Design Review Board Study Session

SUBJECT: DR14-33, PADS B AND D AT AZ AVE WINCO

DR14-33, Pads B and D at AZ Ave Winco: site plan, landscape plan, grading and drainage, elevations, floor plans, lighting, colors and materials for approximately 2.0 acres located at the northeast corner of Arizona Avenue and Desert Lane zoned General Commercial (GC) with a Planned Area Development (PAD) overlay.

PHOTOMETRIC PLAN

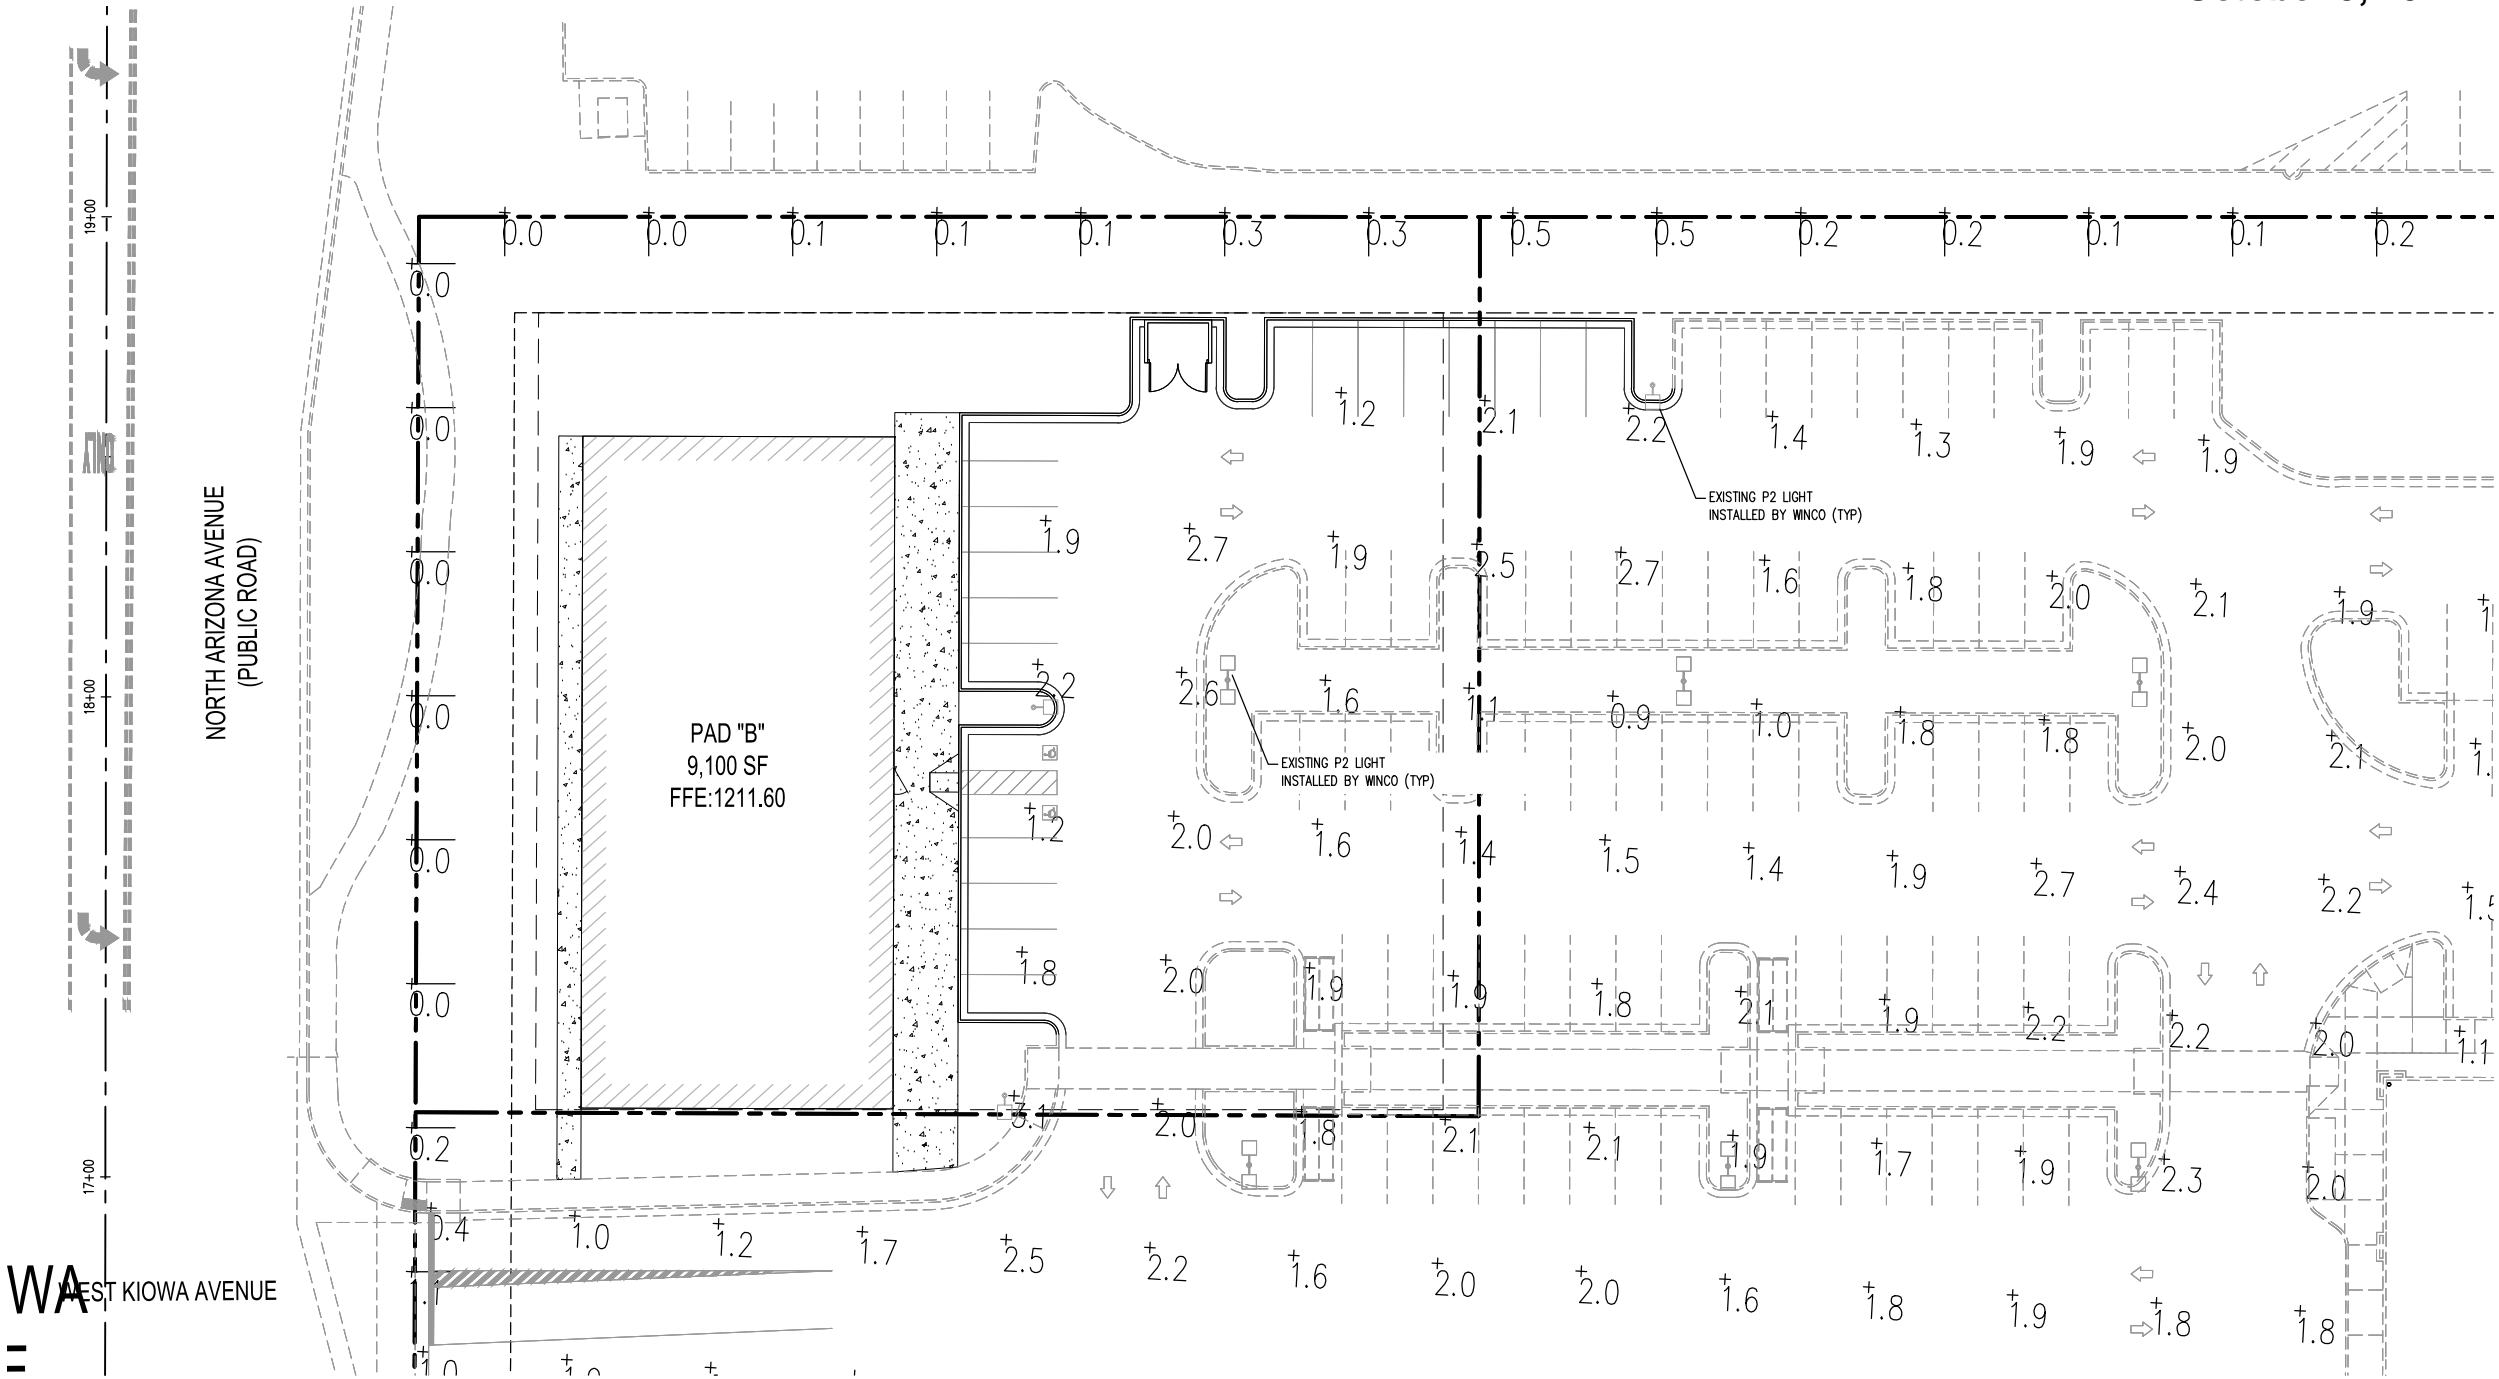
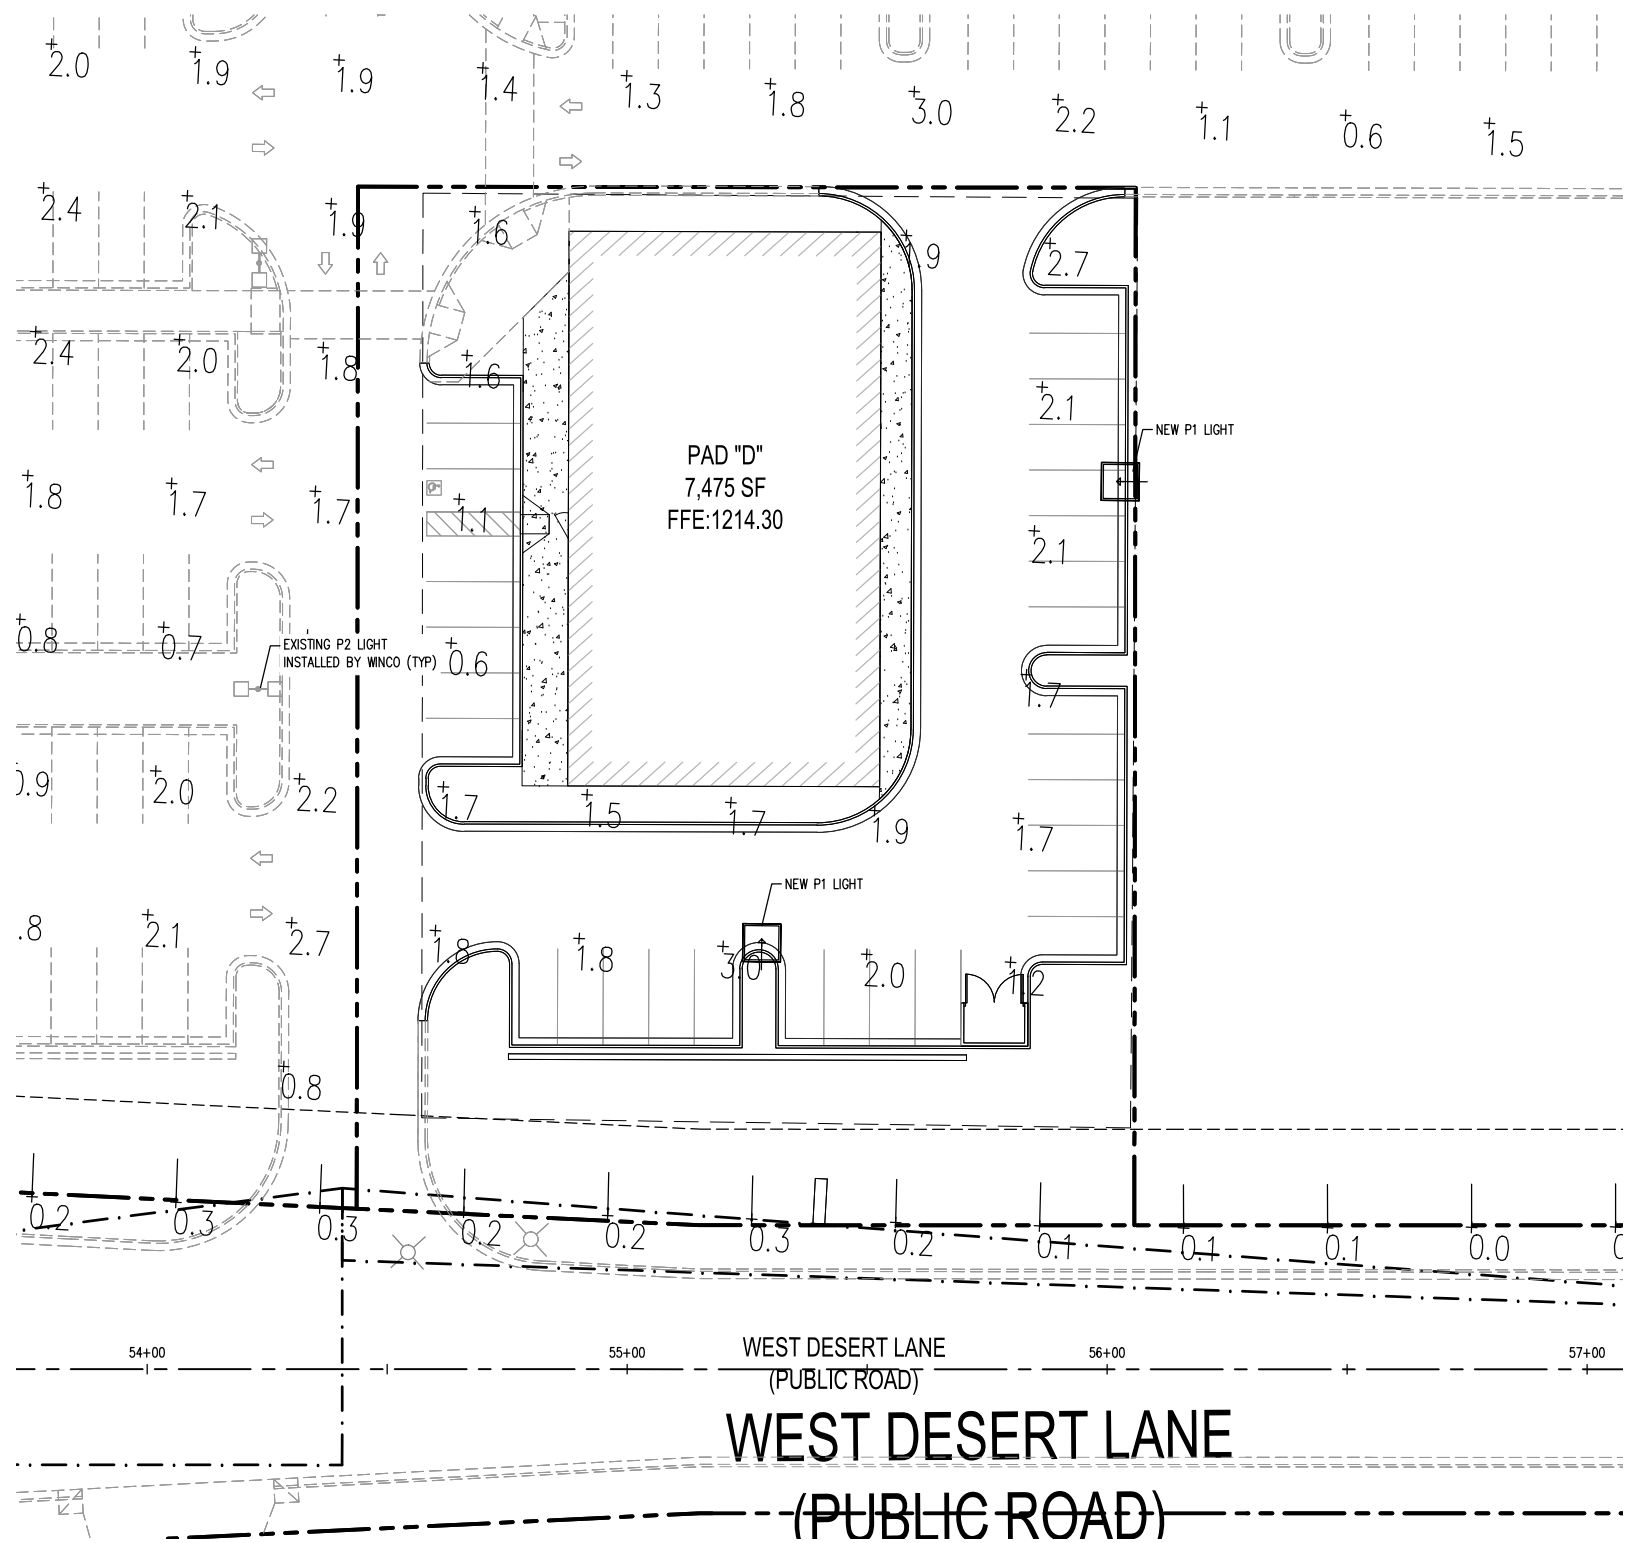
New site lighting will match the existing parking lot lights. The building lighting shown on the elevations shall be depicted and specified on the photometric plan as part of the 2nd Review.
